RANCHO PALOS VERDES

TO: CAROLYN LEHR, CITY MANAGER
FROM: RAY HOLLAND, DIRECTOR OF PUBLIC WORKS
DATE: JUNE 29, 2011
SUBJECT: WEEKLY ADMINISTRATIVE REPORT

LADERA LINDA

City of Rancho Palos Verdes Draft Working Doc.

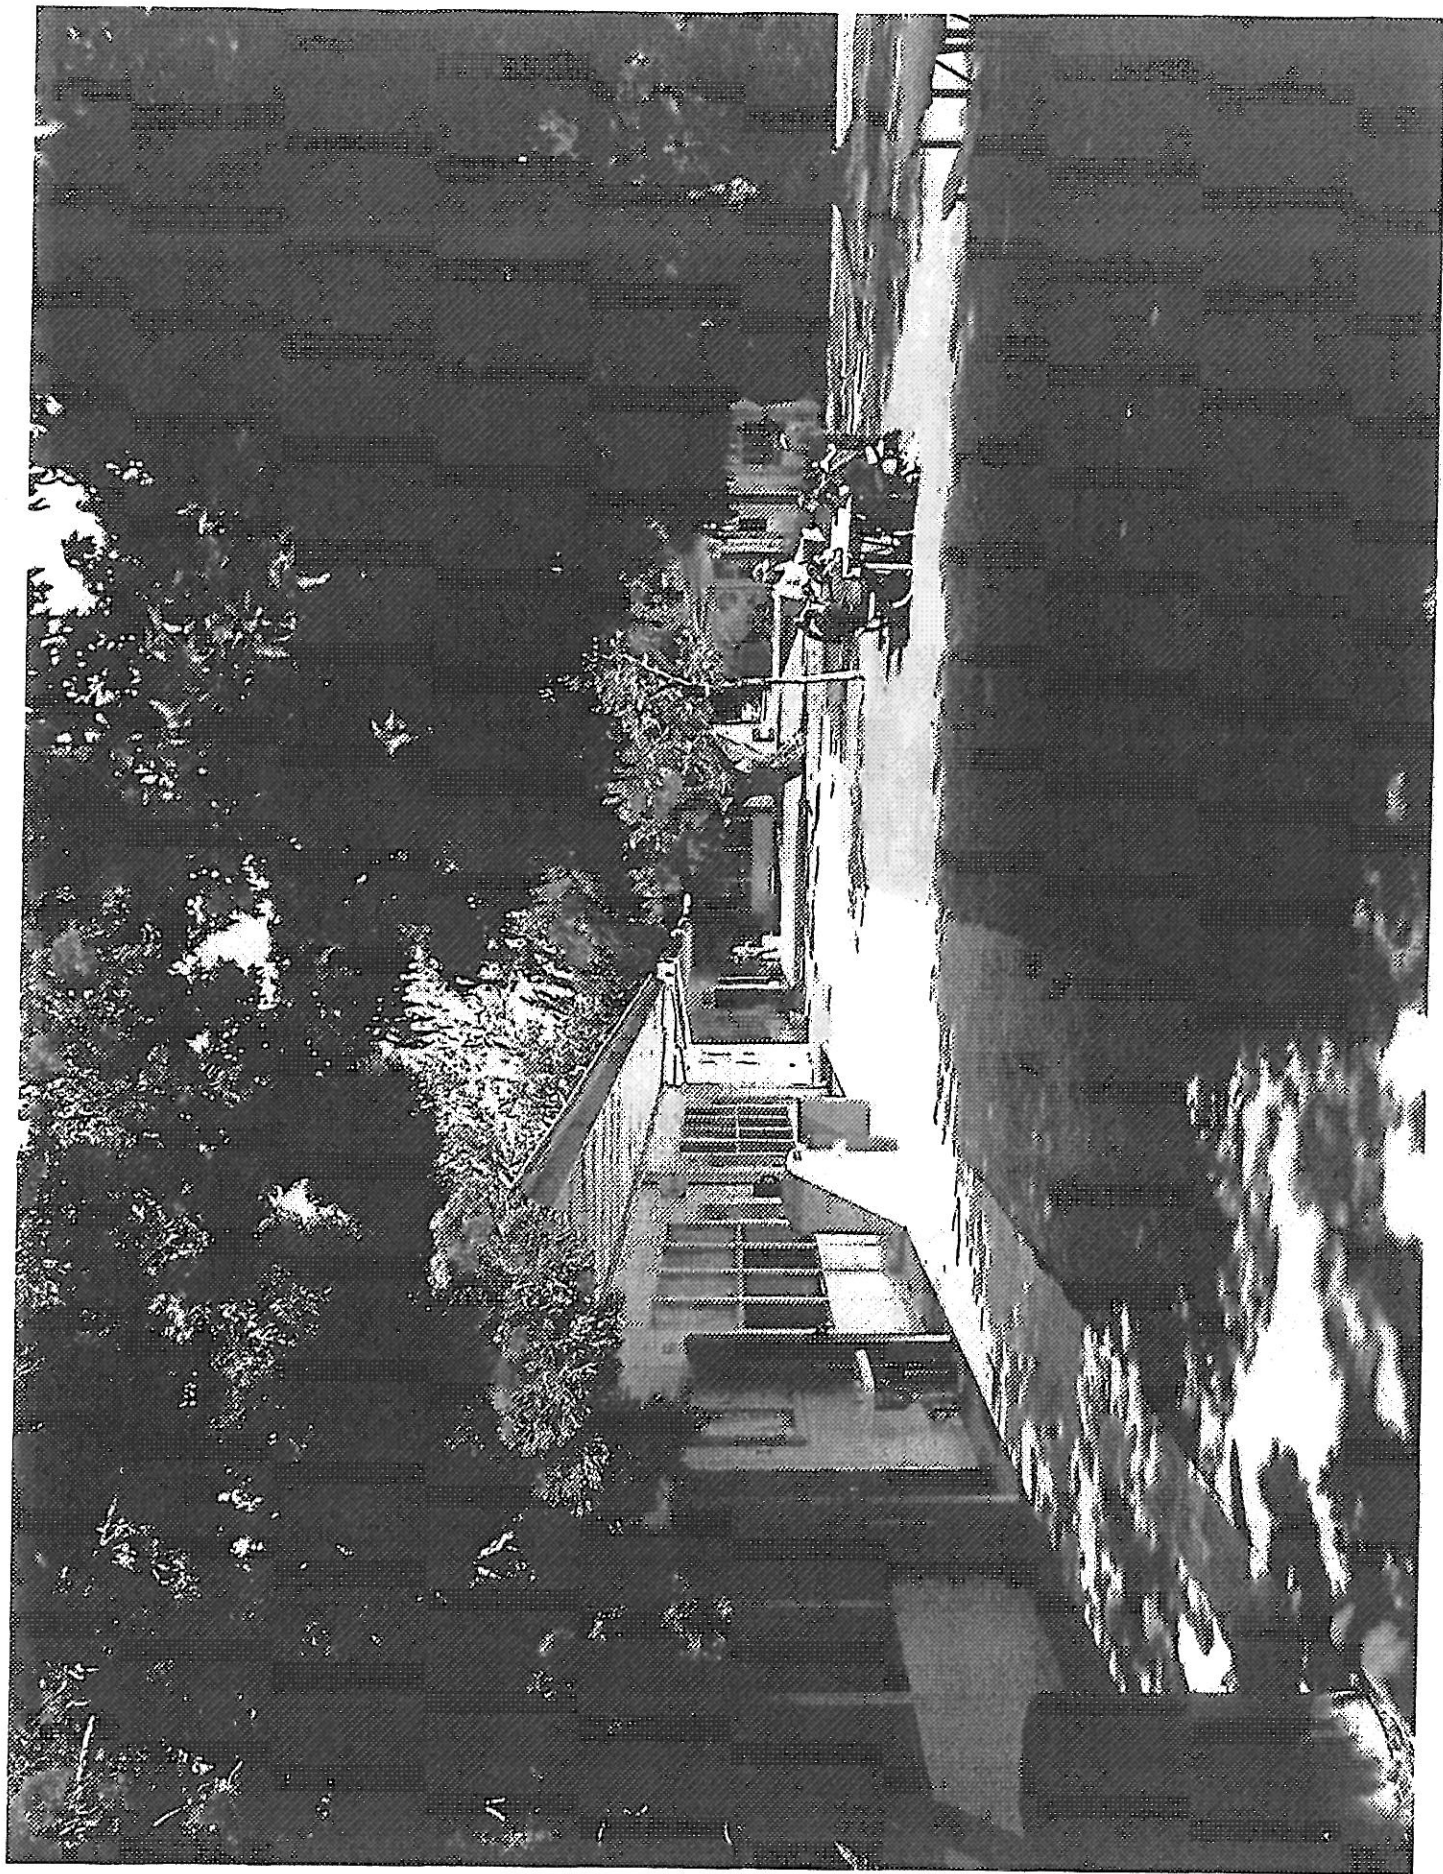
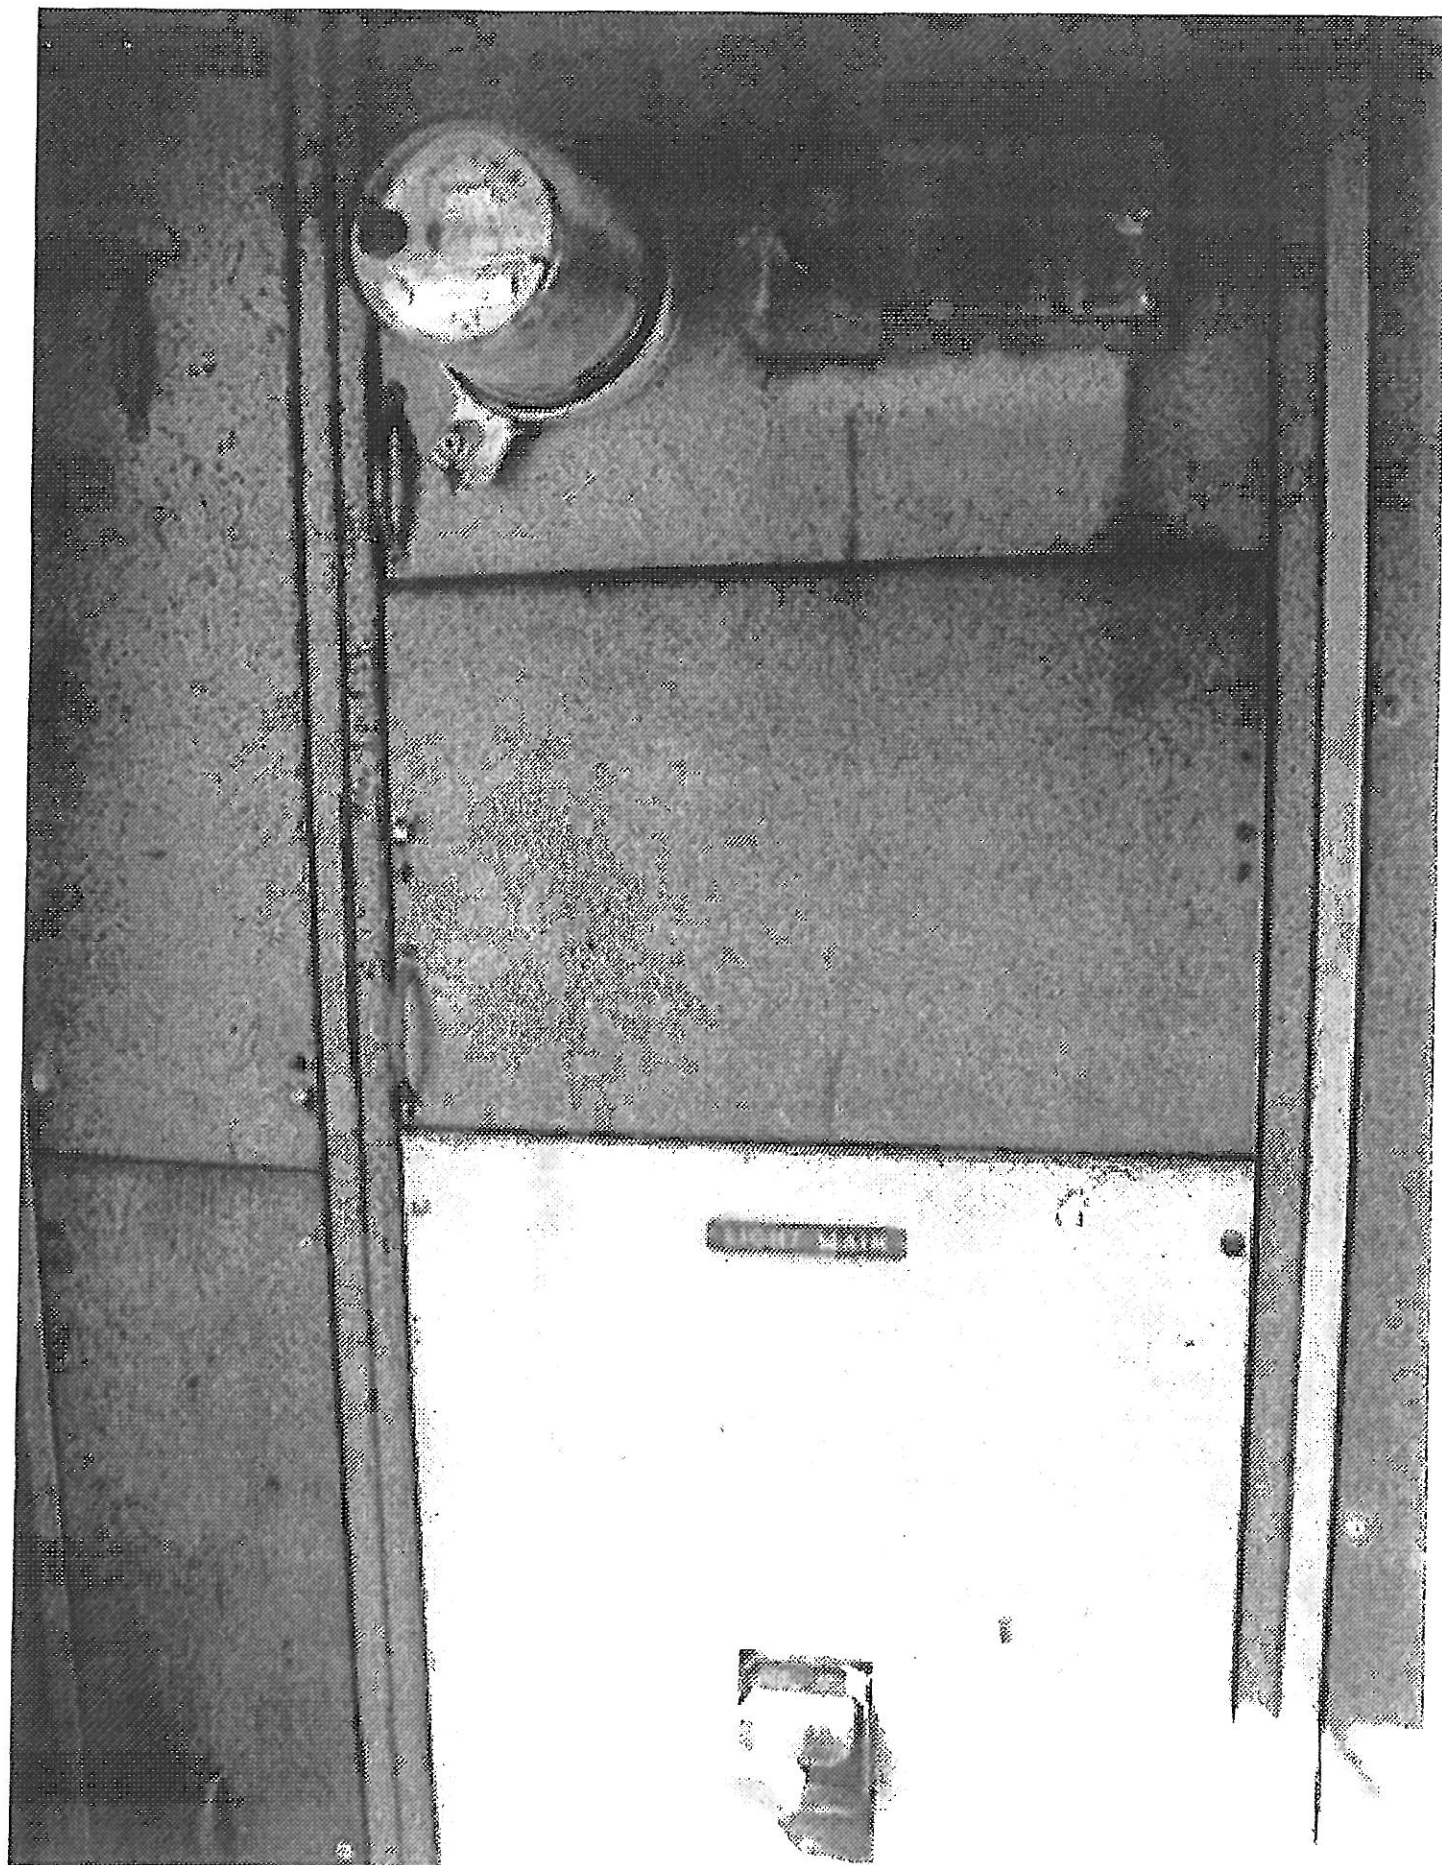
<p>The valley/bowl locations of this site makes it prone to mudslides and drainage issues from the adjacent hillsides. (This condition affects the upper road areas leading to the hiking areas).</p>	<p>The grounds and the buildings for their age, and given the sites location in the salty ocean air, are very well maintained. The same can be said for the interiors of the buildings we went through.</p> <p>Site pad. The facility sits above a residential neighborhood towards the ocean. The embankment between them is an irrigated landscape, with a series of "V" ditches horizontally, and looks very stable in terms of erosion. The embankment on the opposite side, from the parking lot up to Forrestal Drive, also seems to offer protection to the site. On site the storm drains appear to be well located in terms of placement and elevation. A good portion of the storm water runoff from the playground / parking area terrace above flows down to the Ladera Linda parking lot. This parking lot appears to be in fair condition, and will need resurfacing in the near future. It seems to have good drainage. It is vital that the storm drains and irrigation systems continue to be well maintained.</p>

<p>The building is not weatherproof in some areas, since the irrigation system this corroded the exterior wall panels. (Wall panels have been patched or replaced).</p>	<p>Structures. The buildings appear to be a prefabricated, assembled on site, interlocking metallic panel constructed, school class room type units. Each rectangular shaped unit consists of one long and two short - more or</p>

<p>Current construction does not comply with current seismic, fire/life-safety requirements. (This was not required at the Time/Date of original construction).</p> <p>Portions of new storage area additions are not fire resistive or 1 hour construction. (Condition remains on the addition area. The detached shed building will be relocated).</p> <p>Door heights of less than 6'8" high in building B (Conditions still remain).</p> <p>Fire/Life Safety: No fire sprinklers. (This was not required at the Time/Date of original construction).</p>	<p>less solid walls (with short, high windows in the rear long wall), and a front wall composed of windows and doors across the majority of it. The roof extends as an owning cover, over the front wall.</p> <p>Some of the panels have been patched, and an occasional vertical trim piece (located between each panel) is coming loose. One such trim piece moved enough to show that the panels do have an interior connection between them, yet it is hard to know how important a connective value the screws on both sides of these vertical trim pieces play, in holding the buildings together structurally. And although the building exteriors are routinely painted, it is as difficult to know how well the vertical and horizontal exterior fasteners have maintained their strength over the years in the weather, as it is to know how well the walls are anchored to their foundations. Yet the front walls, by their very openness in terms of wall area, appear weak in terms of shear.</p> <p>The fencing around the electrical service equipment area has significant dry rot damages around its base.</p> <p>From the stairs to the play equipment yard above, the roof on building "J" and "K" looked to be in good condition.</p>

<p>Accessibility: No approved fully accessible restrooms exist. Missing ramps from the classroom doors to outdoor areas on the west side. The required door edge side strike clearance is not a minimum of 18" on the pull side of 12" on the push side at some of the doors. No lever hardware on the doors. Over ½" high door thresholds. Excessive slope at the ramp to the lower play yard. No ramp or lift to upper play yard. (Construction work with a 2011 valuation of \$132,536.28 or more triggers accessibility upgrades).</p>	<p>The classroom type buildings, restrooms, and grounds are existing, nonconforming in terms of accessibility.</p>

<p>Added west facing exterior doors leading to the play yard areas open up over a step down. Improper size landings were installed and no ramps were installed. Interior doors were installed that are less than 6'8" tall.</p> <p>Missing required door landings on the exterior side of building B. (Condition still remains).</p>	
<p>Electrical service is exposed to the weather and is located in areas subject to flooding. (Overhead roll up door must be kept closed to prevent weather exposure).</p> <p>Some of the sub panels have "Pushmatic" breakers which have been listed on a product alert or recall from the Consumer Product Safety Commission. (New breakers and sub panel was installed).</p> <p>Extension cords are being used as a substitute for permanent building wiring. (Condition changes based on tenants needs, Education on the use of cords or additional outlets can be provided).</p> <p>The electric conduit has corroded on the west side of the building where it rises from below the ground repaired with roof sealing material. (Condition was not found to be hazardous; upgrade/replacement of electrical utilities is anticipated).</p>	<p>Electrical. The electrical service, from the outside appears rusted, and is exposed to the atmosphere. It may well be that the electrical connections and components inside are deteriorating as well. The sub panels are antiquated. The sub panels in rooms "J" and "K" are labeled in a contradicting fashion. One roistered with "X-1" crossed out and with "D-1" next to it, indicating the panel disconnect at the service equipment The other showing both circuit breakers could be the disconnecting means. Receptacle placement is sparse- the office area receptacles look over loaded, with numerous cords plugged into them. The panel and circuit breakers in the custodial closet have no labeling, and projection from the wall intrudes on its working space. It appears that the whole electrical system is nearing or has reached the point needing replacement.</p>

<p>Leaking and deteriorating gas, waste, and water lines. (Conditions remain. Use of gas piping has been discontinued).</p> <p>Missing earthquake straps for the water heater(s). (Electric water heater installed with seismic straps).</p> <p>The water heater t&p drain needs to be run to the exterior of the building. (Electric water heater installed on the exterior).</p>	<p>Plumbing. It sounds as though a portion of the building sewer has been relined, yet that problems remain with both the building sewer and drain systems, both of which perhaps are nearing or have reached the point of replacement. It appears that the water piping was plumbed with copper pipe in the bathrooms, visible from an access panel in the custodian's closet. No signs of leaking were observed. The condition of water piping underground is unknown. The bathrooms have accessibility issues. Per the city report, the water heaters are non compliant in terms of earthquake strapping, and pressure temperature relief valve piping. Those units</p>

<p>The water supply shut off valves are not operable at many areas. (Conditions remain but new plumbing work has operable valves).</p> <p>Water to added preschool toilets was connected to irrigation line and also without a separate shutoff valve. (Condition remains).</p>	<p>out of site of their electrical panels, had no disconnect. Also per the city report, the bathrooms, and classroom sinks have accessibility issues.</p>
<p>The heating systems in the classrooms are very old and the flames were not all blue. This might indicate that there is a hazard of carbon monoxide which should be checked out by a gas company representative. (Use of gas heaters has been discontinued).</p> <p>The mechanical and electrical equipment is not seismic braced. (This was not required at the Time/Date of original construction).</p>	<p>Mechanical. The forced air heating equipment on site is original, and most likely so inefficient that it isn't worth repairing. The "temporary" electrical heaters are too small to provide comfort in the classrooms, and perhaps should be removed as a safety measure.</p>
